Crankcase/Pistons/Piston Rings Need to Be Replaced - Mixed Installation is Not Permitted (25/13)

This Technical Information replaces the TI dated May 8, 2013.

Concerns: **Cylinder liner in crankcase**

Figure 1

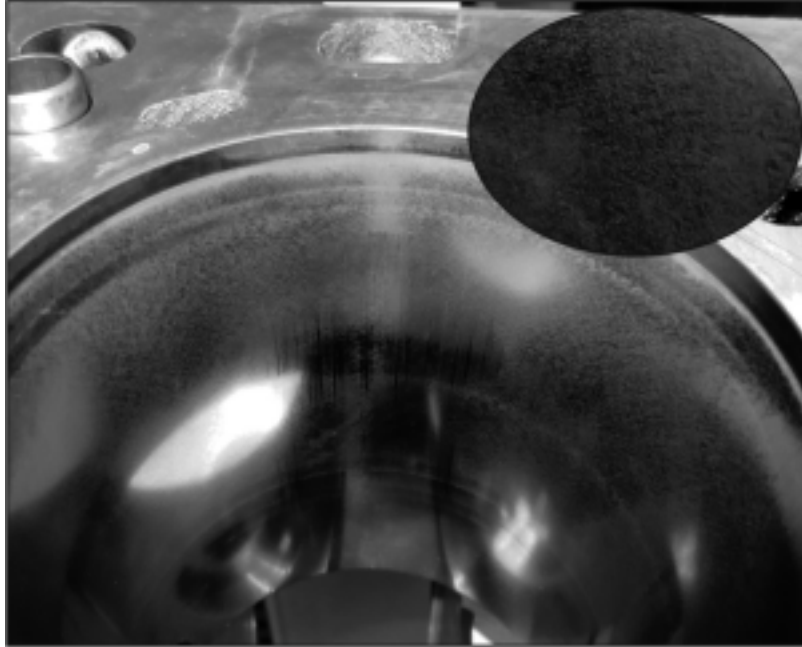
A) Cylinder liners are smooth-honed (⇒ *Figure 1*, old - crankcase no longer available)

• **Spare parts requirements:** Crankcase (old type, smooth-honed - no longer available)

• **Spare parts requirements:** One or more pistons and piston rings (old type without DLC coating ⇒ **now available again**)

⇒ **All pistons with piston rings can be replaced again in the usual way.**

⇒ All pistons with piston rings and the crankcase must be replaced with new components.

Figure 2

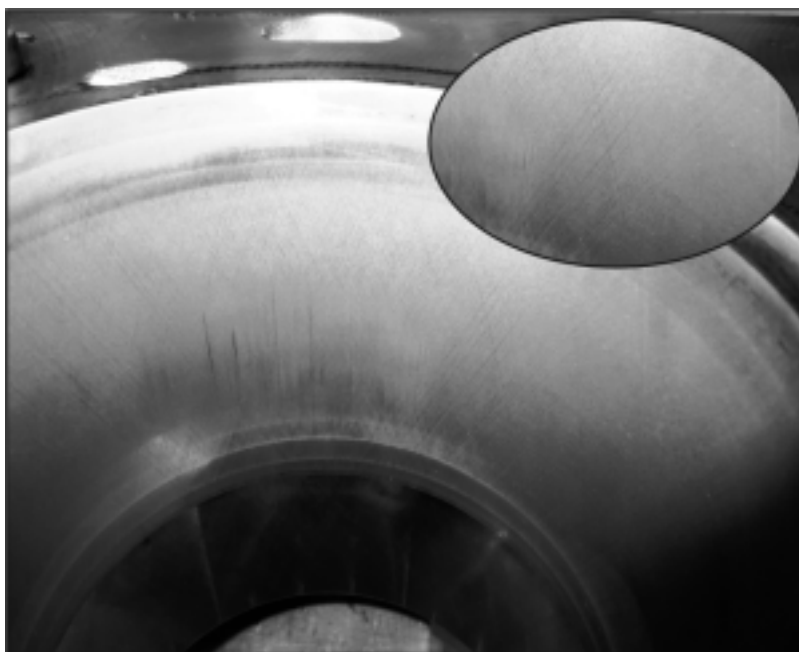
B) Cylinder liners are structurally honed (⇒ *Figure 2*, new type)

• **Spare parts requirements:** One or more pistons and piston rings
 ⇒ **Only replace the required piston(s).**

• **Spare parts requirements:** Crankcase
 ⇒ **Only replace the crankcase.**
